TECHNICAL EVALUATION OF THE ADEQUACY OF  
STATION ELECTRIC DISTRIBUTION SYSTEM VOLTAGES  
FOR THE RANCHO SECO NUCLEAR GENERATING STATION,  
UNIT NO. 1

(Docket No. 50-312)

November 10, 1981

Lawrence  
Livermore  
Laboratory

FIGURE 1 RANCHO SECO ELECTRICAL ONE-LINE DIAGRAM

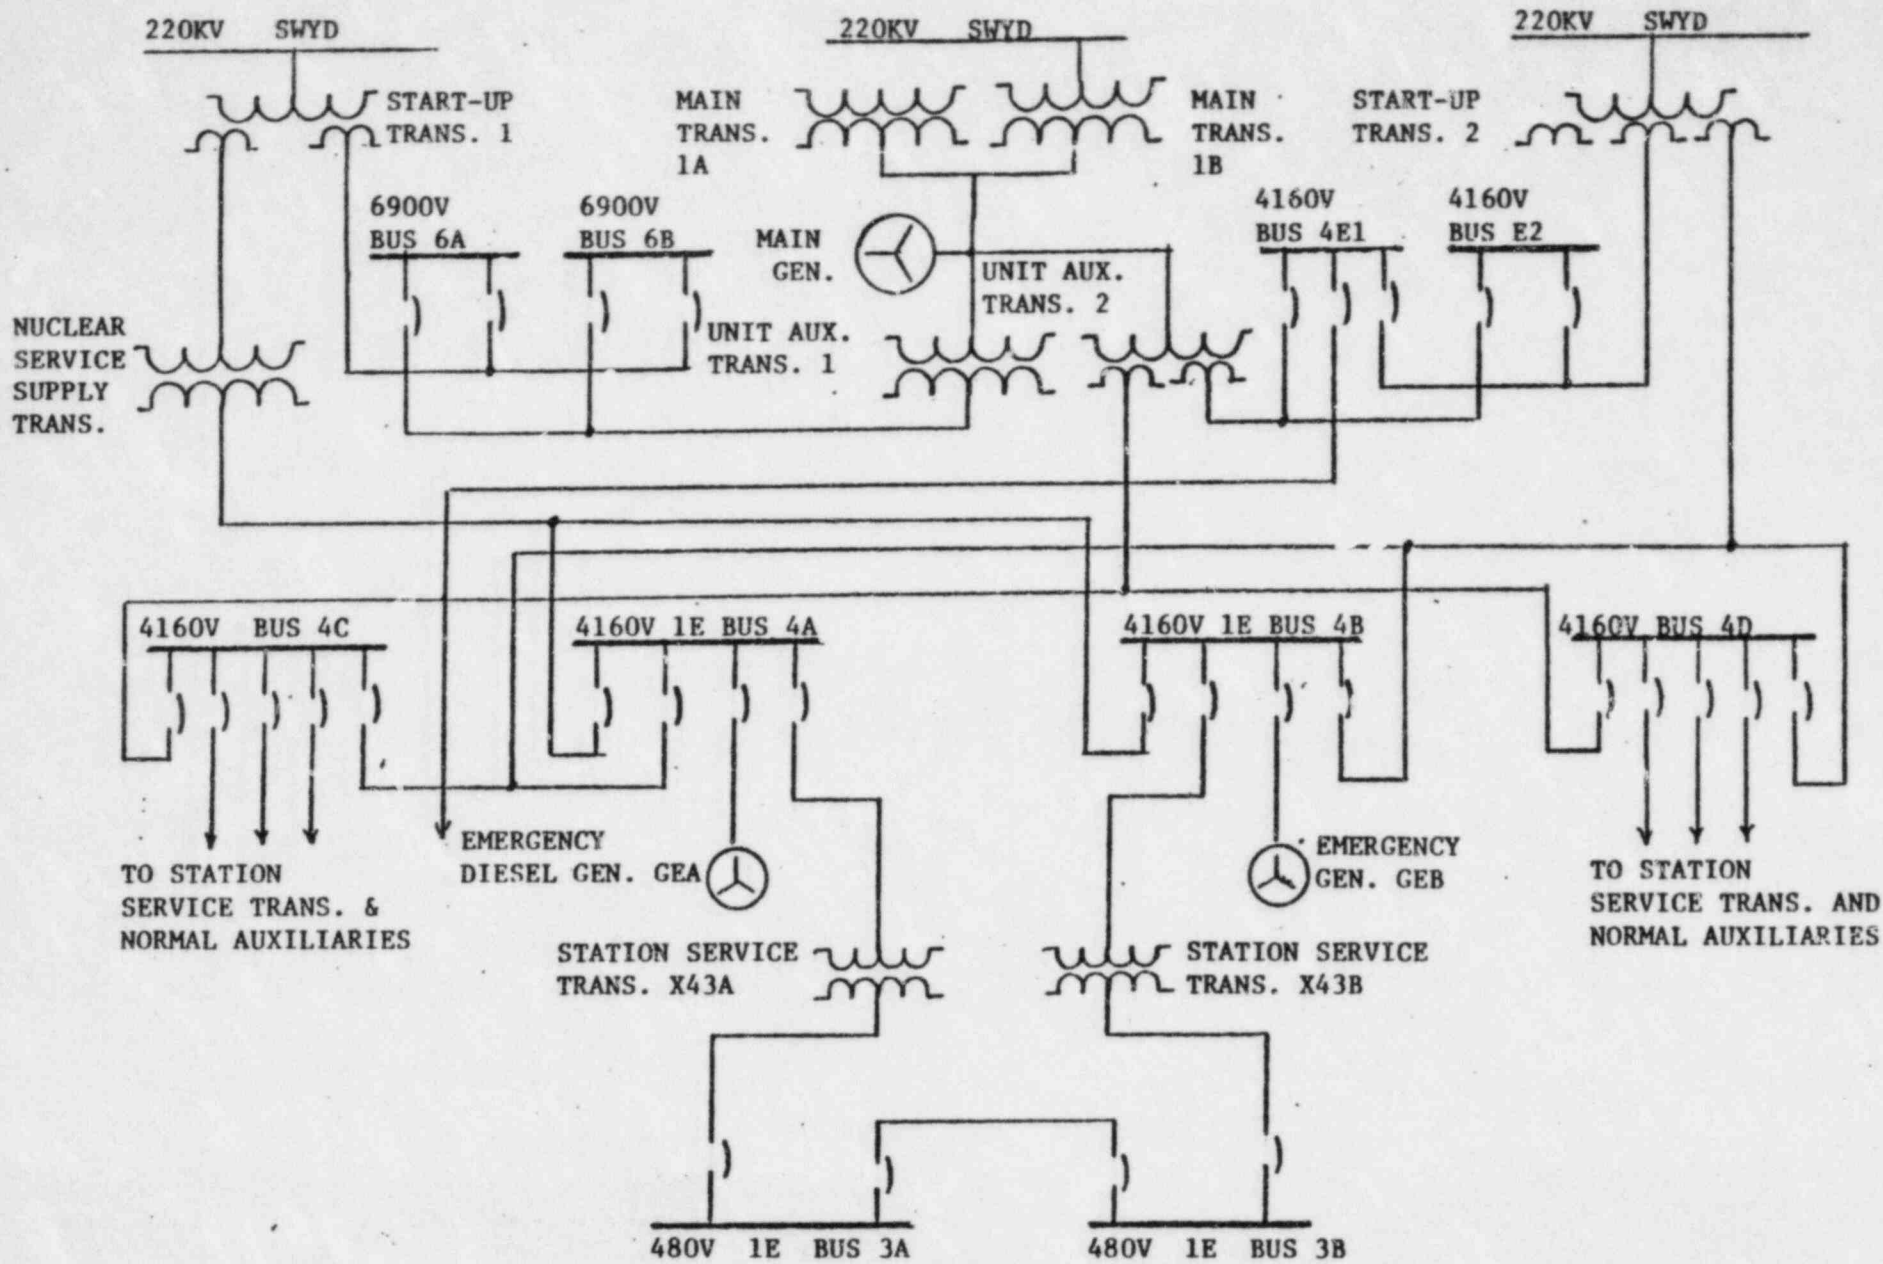
A one-line diagram of Rancho Seco's electrical distribution system is shown in Figure 1. This figure was adapted from Enclosure 1 of SMUD's letter of September 17, 1976 [Ref. 9]. There are two 4160-volt and two 480-volt Class 1E buses. The 4160-volt Class 1E buses, 4A and 4B, are energized through startup transformers 1 and 2. The 480-volt Class 1E buses, 3A and 3B, are energized through station service transformers X43A and X43B. The unit auxiliary transformers are not an available source for the Class 1E buses.

The licensee recently proposed a modification in the degraded grid voltage protection circuitry. The proposal was to protect the Class 1E equipment at Rancho Seco from a degraded grid or loss of voltage by using three undervoltage relays to monitor each 4160-volt emergency bus. These relays are of the inverse time-voltage type, set to operate at approximately 3771 volts (90.6% of 4160 volts). Upon complete loss of voltage, the undervoltage relays will trip in less than 1 second. The details of this modification are covered in Lawrence Livermore National Laboratory report, UCID 18690, entitled "Technical Evaluation of the Proposed Design Modifications and Technical Specification Changes on Grid Voltage Degradation (Part A) for the Rancho Seco Nuclear Generating Plant" [Ref. 10].
